Government of India - Ministry of Railways Research, Designs & Standards Organization, LUCKNOW - 226011

# MODIFICATION SHEET No. RDSO/2016/EL/MS/0454 Rev.'0', Dated 29/04/2016

Provision of Top operated handle for CBC in place of bottom operated.

Fig-1: Photograph of Top-operated uncoupling arrangement for CBC in 3-phase Electric locomotives

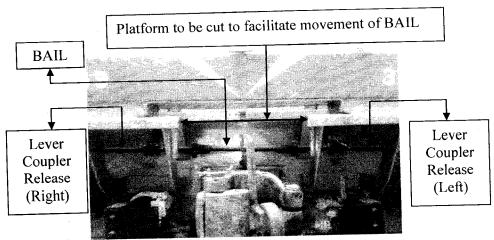
(iv) In 3-phase locomotives, the platform obstructs movement of the Bail and needs to be cut as shown below in Fig 1.
